ADDENDUM NO. 4
TO
CONTRACT DRAWINGS AND SPECIFICATIONS
Dated
July 9, 2007

MAINE TURNPIKE AUTHORITY
ADMINISTRATIVE BUILDING
CONTRACT NO. 2007.07

A/E PROJECT NO. 06016

Date of Addendum Issuance: August 10, 2007

PM: SLB
 A/E: SLB
 DATE: 8-10-07
 ADDENDUM No. ADD-4
 SKETCH No. A-2
 © COPYRIGHT 2007 SMRT INC.

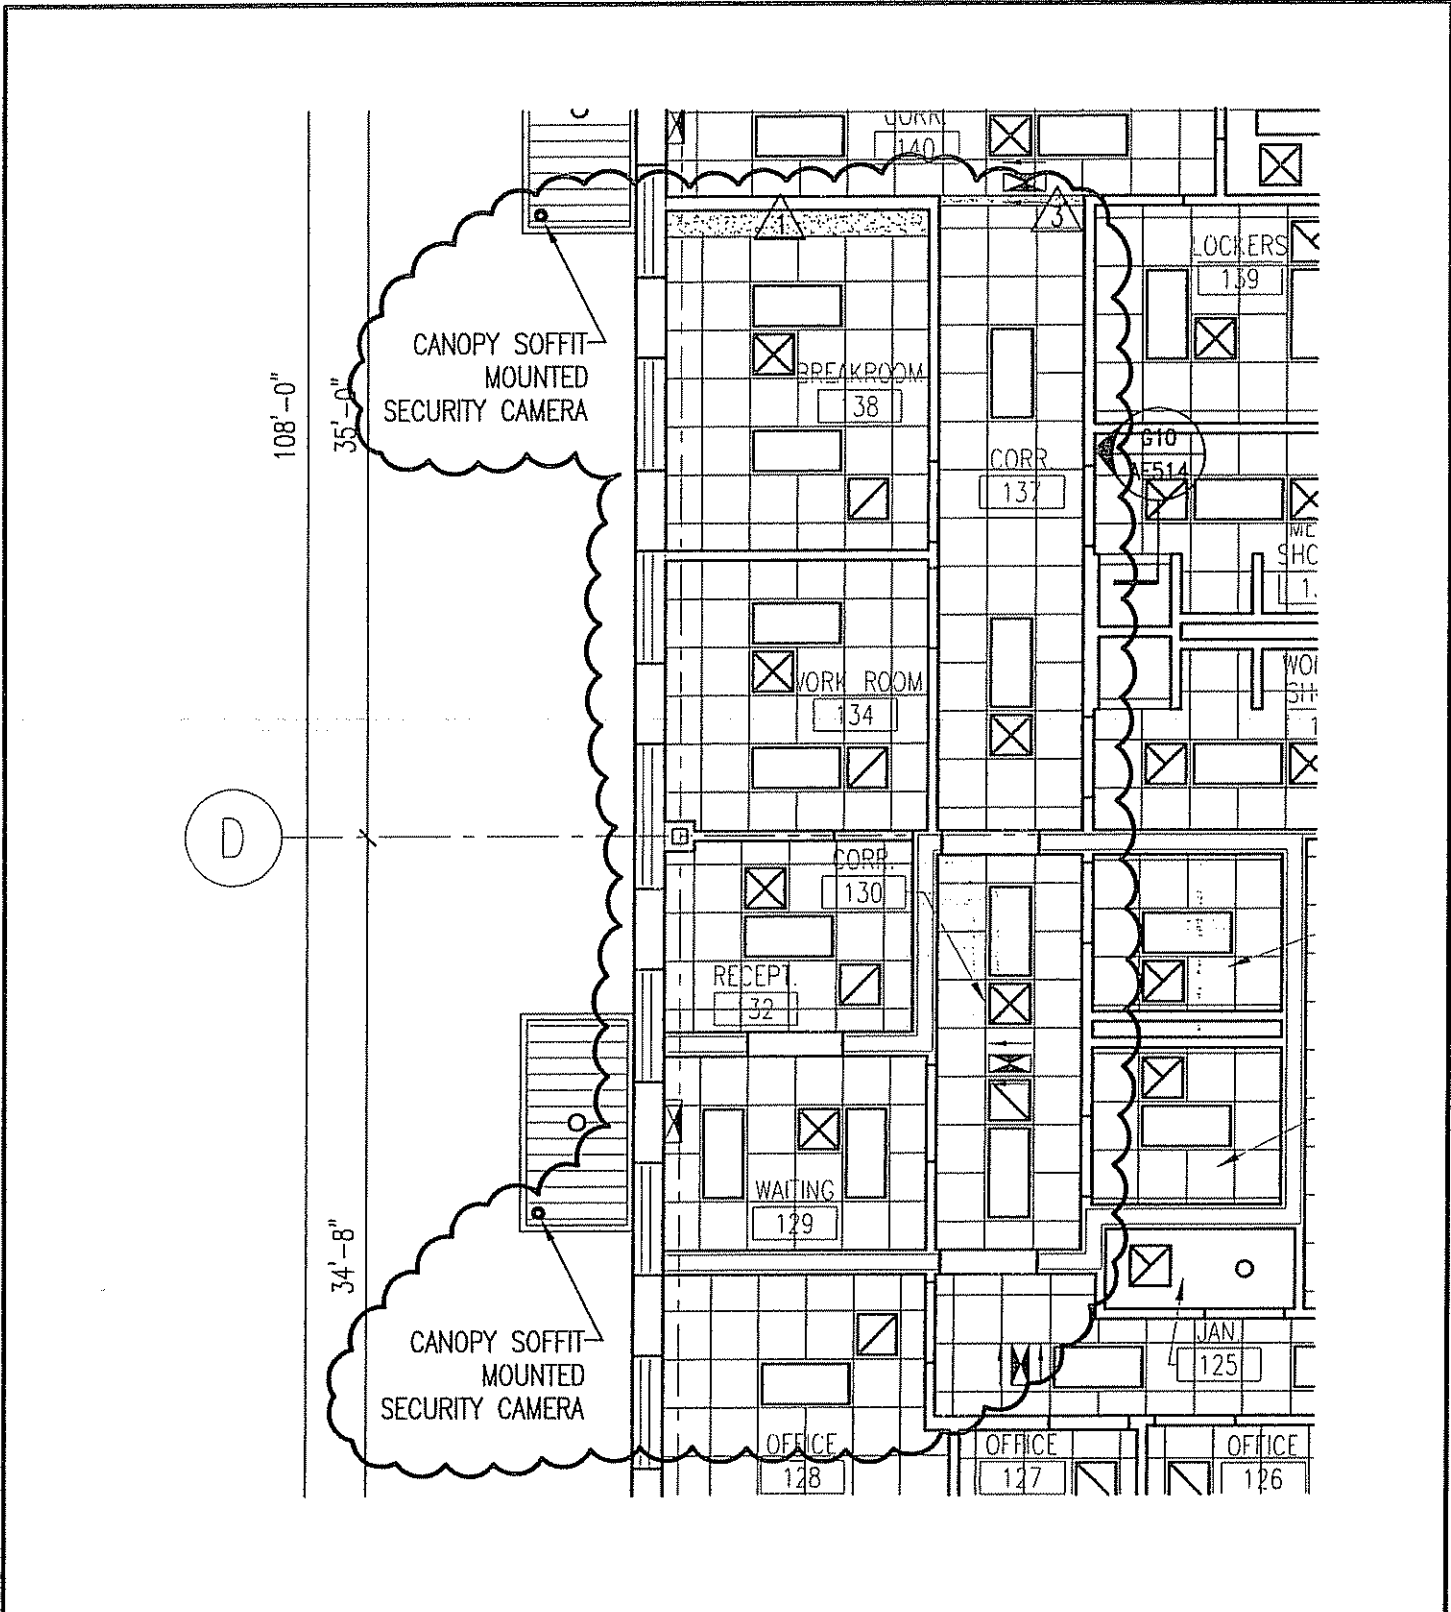
- a. Revise dimensions at Corridor 137 as described on A-2.

SCALE:	1/8"=1'-0"
CAD FILE:	AE122-06016
PROJECT No.	06016
REF. SHEET:	AE122
PM:	SLB
A/E:	SLB
DATE:	8-10-07
ADDENDUM No.	ADD-4
SKETCH No.	A-6
© COPYRIGHT 2007 SMRT INC.

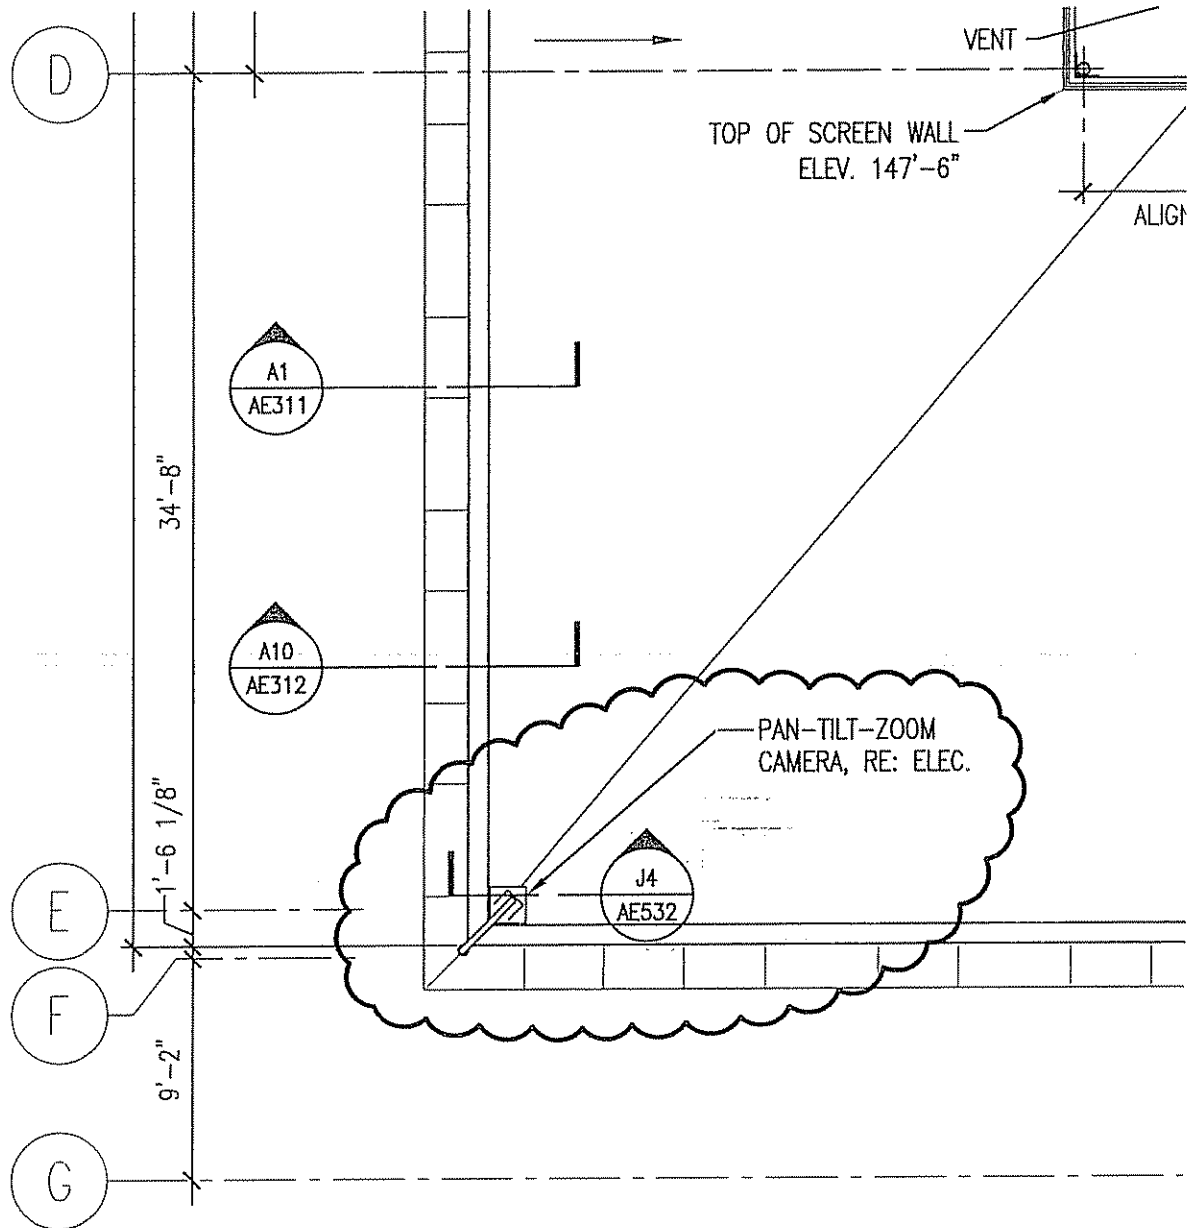
- c. Locate soffit mounted cameras as described on A-4, A-5 and A-6.
9. AE131 – ROOF PLAN:
 - a. Locate cameras as described on A-7 and A-8.
10. AE218 – INTERIOR ELEVATIONS:

PROJECT: MAINE TURNPIKE AUTHORITY
ADMINISTRATION BUILDING
SUBJECT: E9/AE218 INTERIOR ELEVATION
REVISED AS NOTED

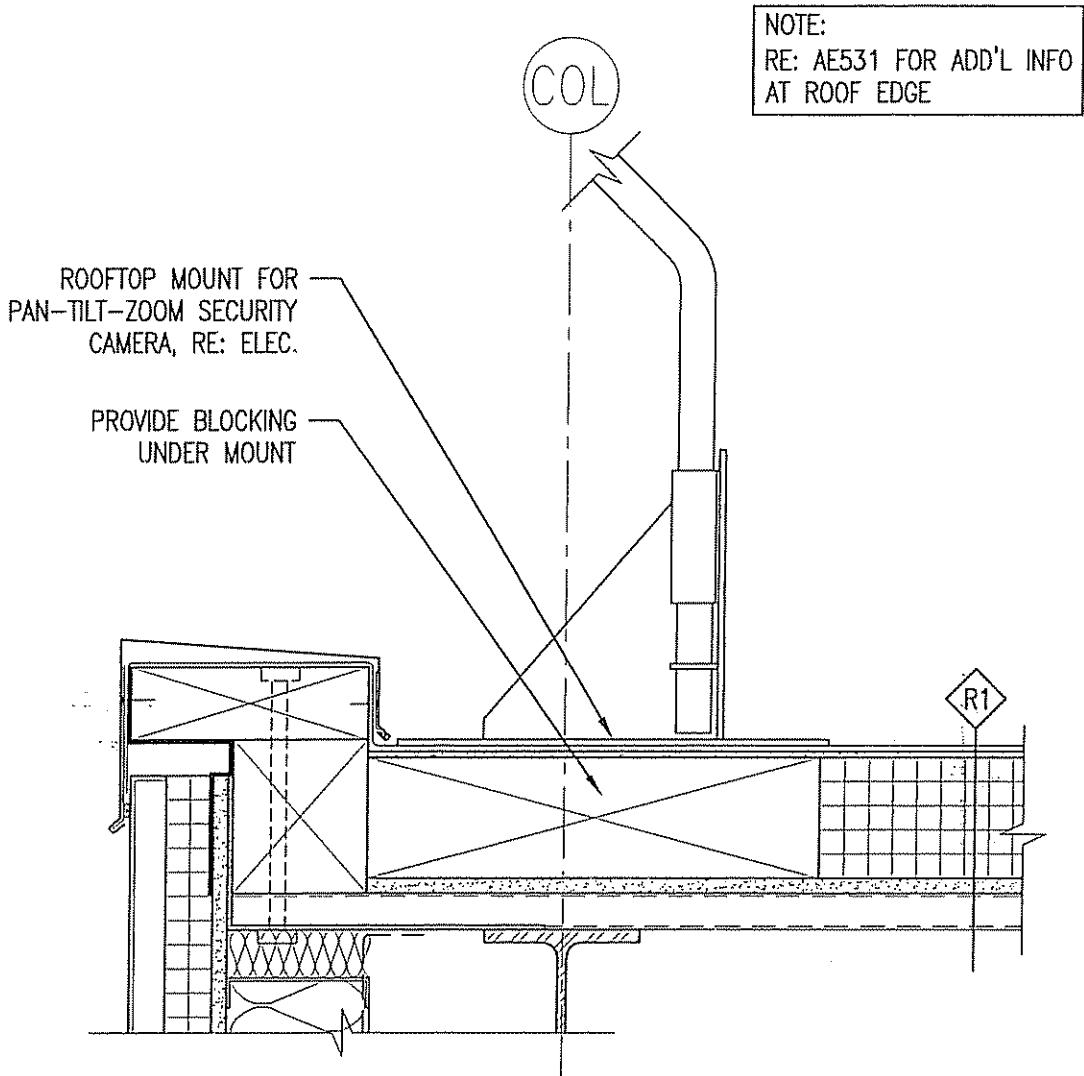
- a. Revise layout at kitchenette in Break Room 138 as described on A-9.
11. AE402 – MAINTENANCE BUILDING PLANS & ELEVATIONS:
 - a. General Notes, Note 5: Revise to read "... three coat fluoropolymer finish on both metal wall and roof panels...."

SUBJECT: ADDED J4/AE532
CAMERA MOUNT @ ROOF

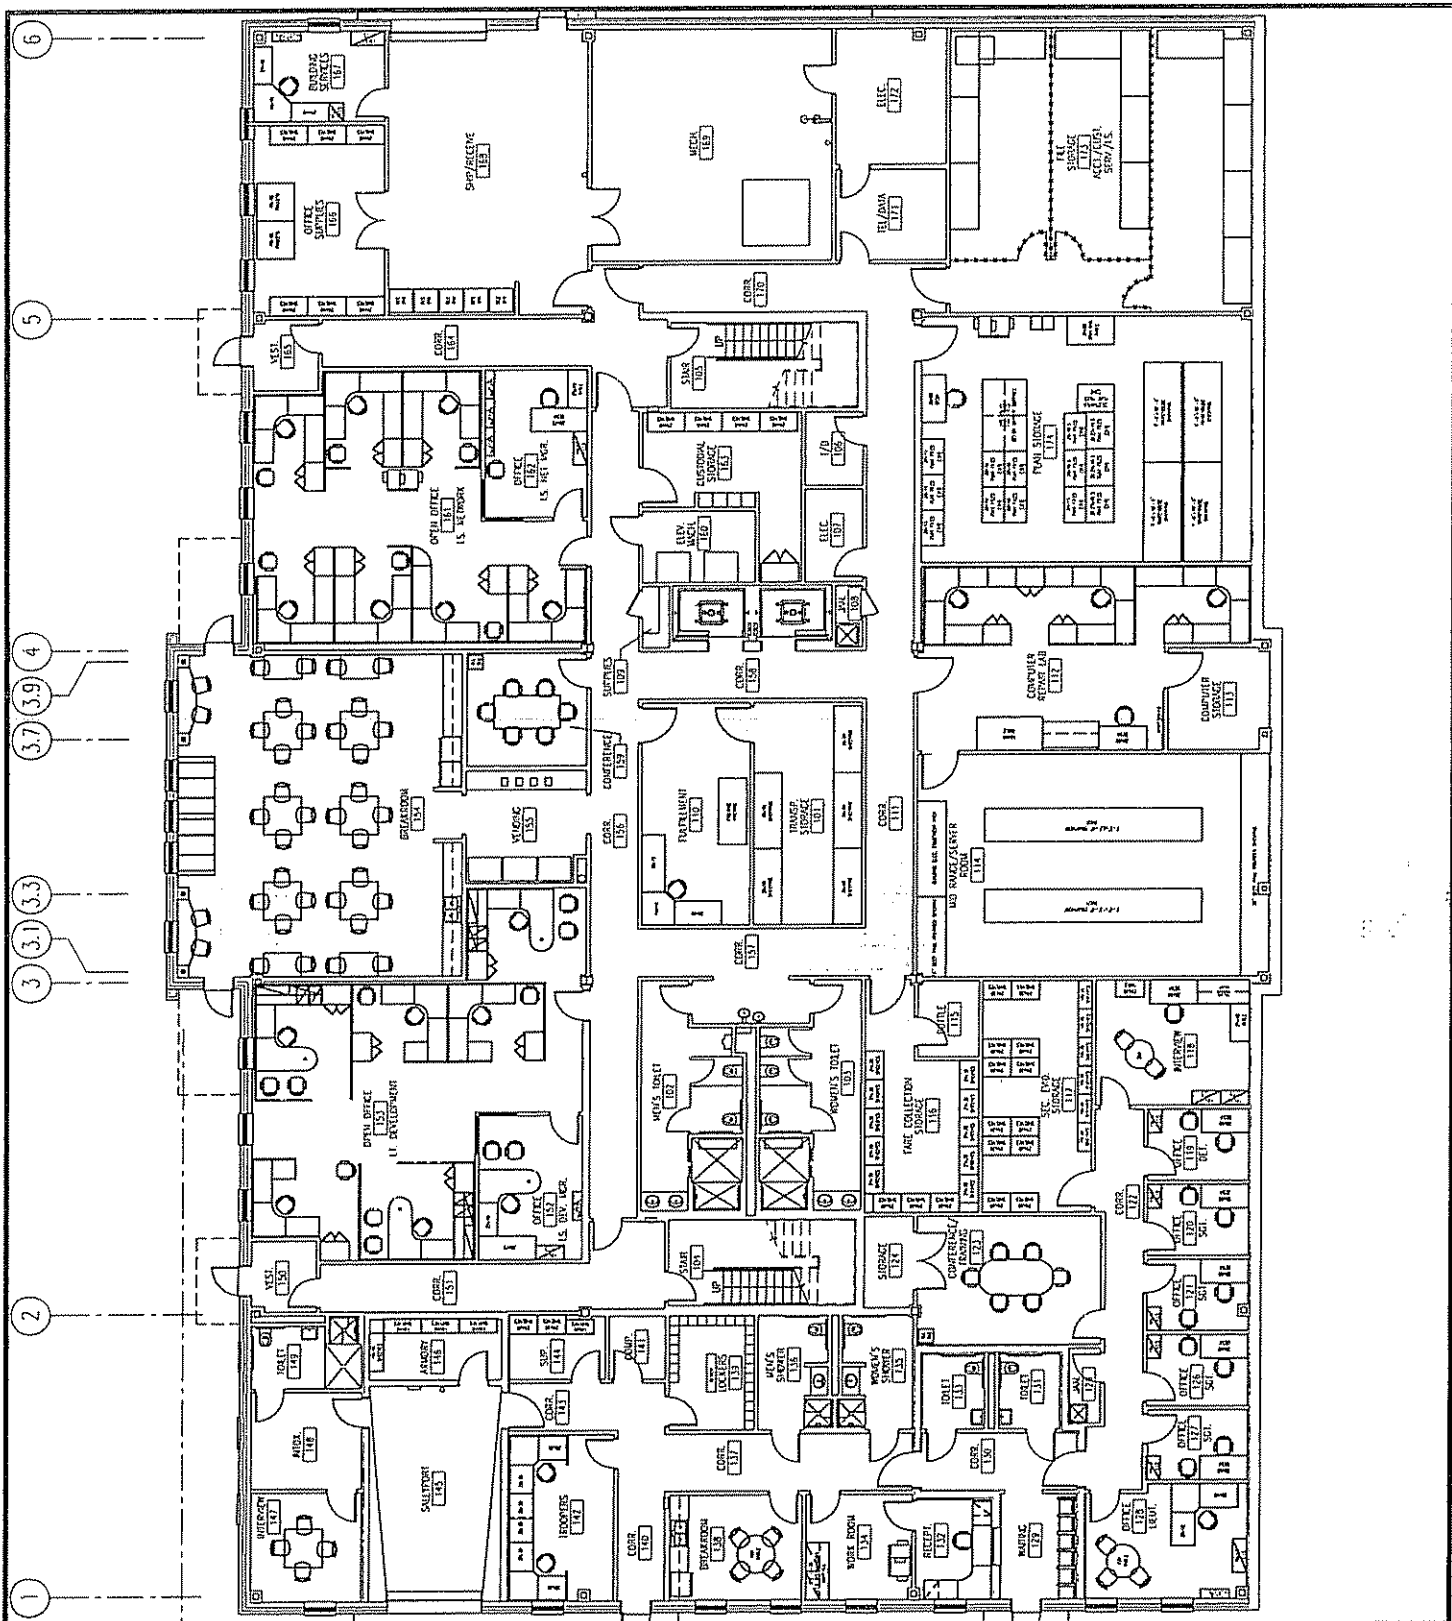
12. AE532 – BUILDING AND WALL DETAILS:
 - a. Install rooftop mounted camera base as described by A-10.
13. ES101 – ELECTRICAL SITE PLAN:
 - a. Revise the pole height for the Type AA fixture closest to drawing coordinate B/10 from 25 ft. to 20 ft.

SUBJECT: FIRST FLOOR PLAN
REVISED AS NOTED

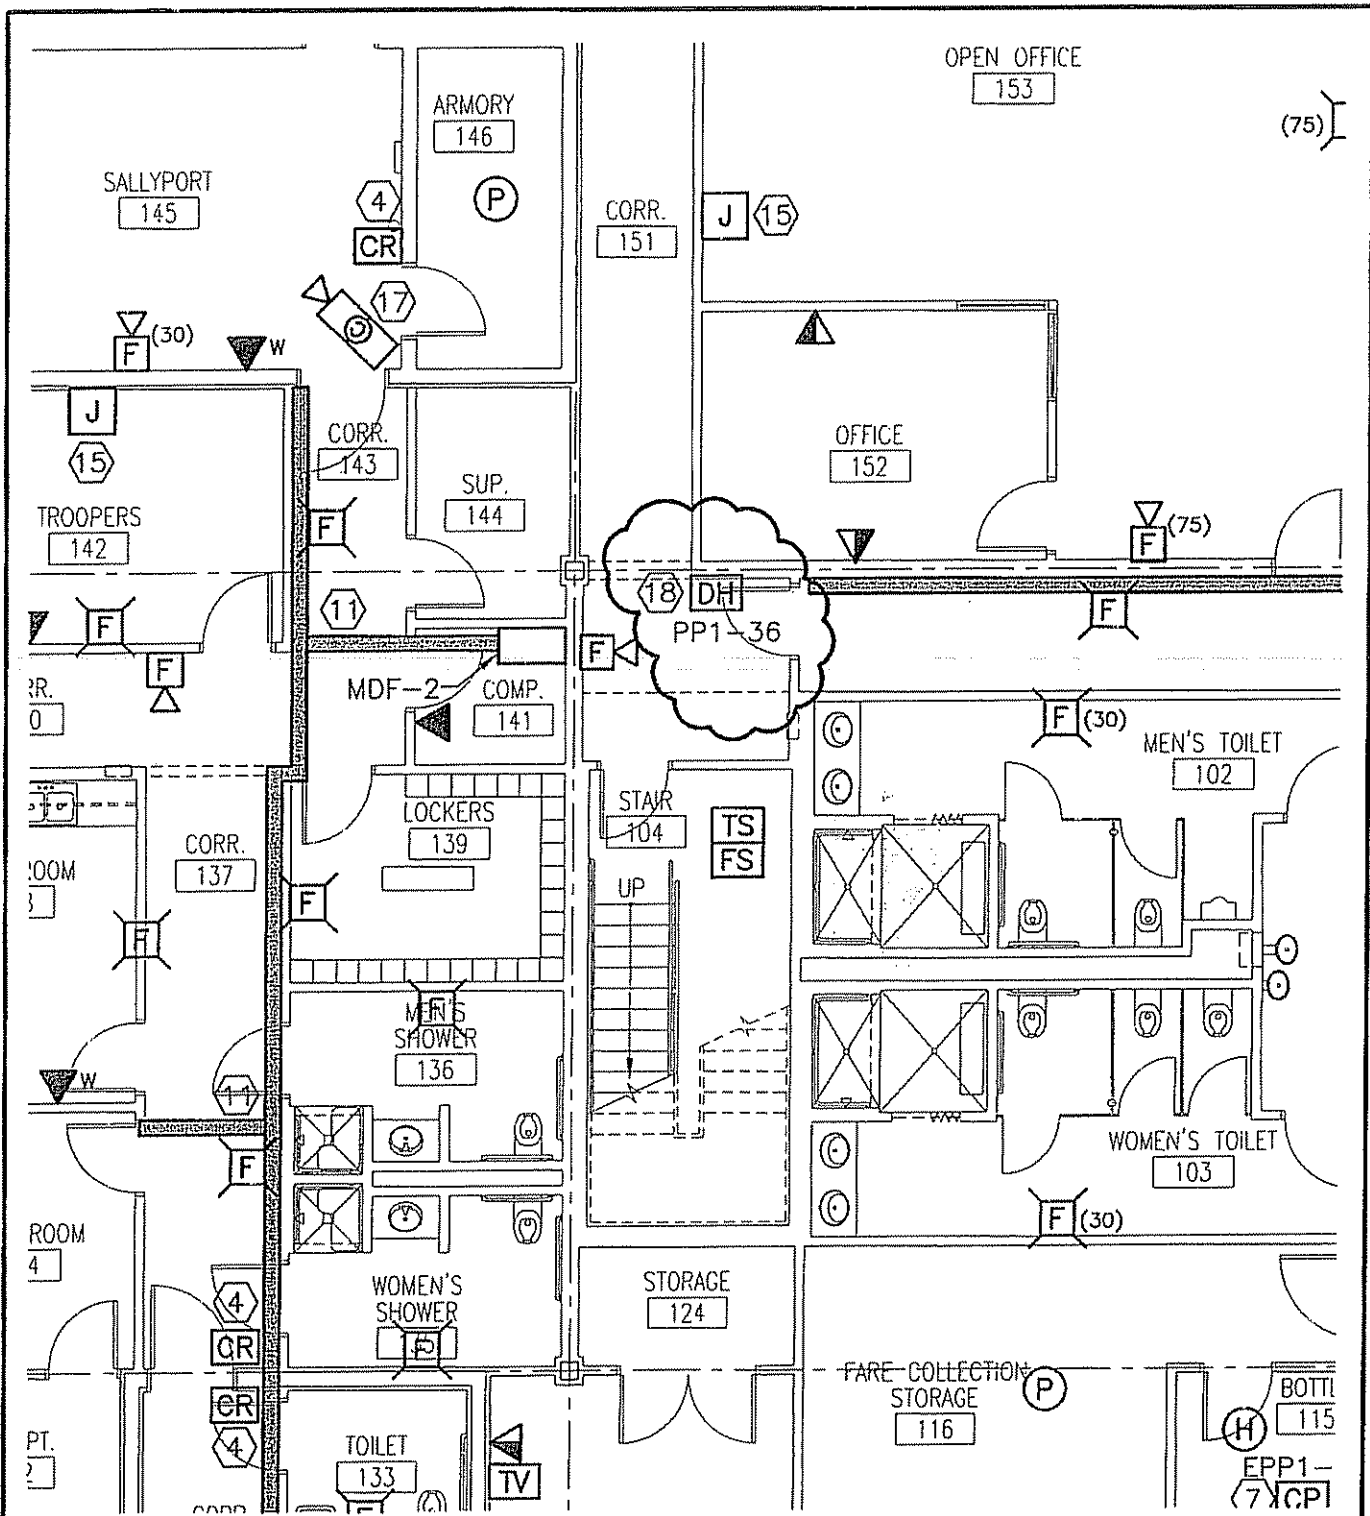
- b. Revise the window tag adjacent to Door No. 168c from “A3” to “A10.”
 - c. Revise door swings 131, 133, 135 and 136 as described on A-1.
7. AE111 – FIRST FLOOR LAYOUT PLAN:

ADD-4
E-3

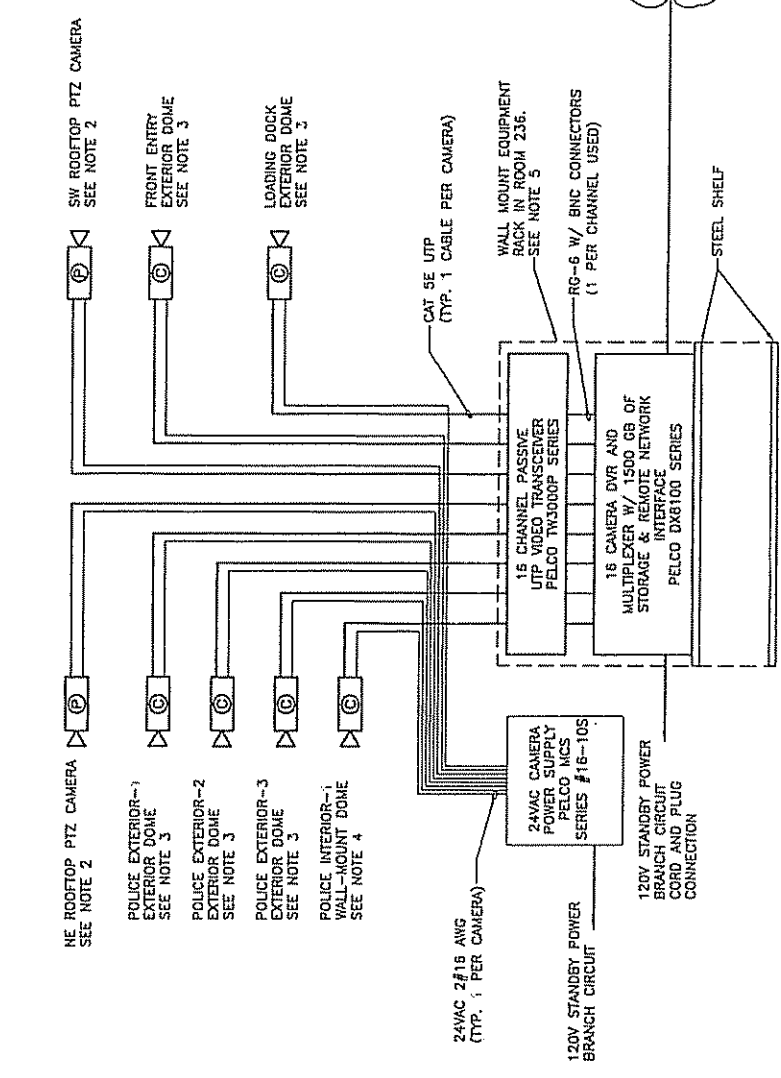
a. A1: Replace with attached Sketch No. E-3.
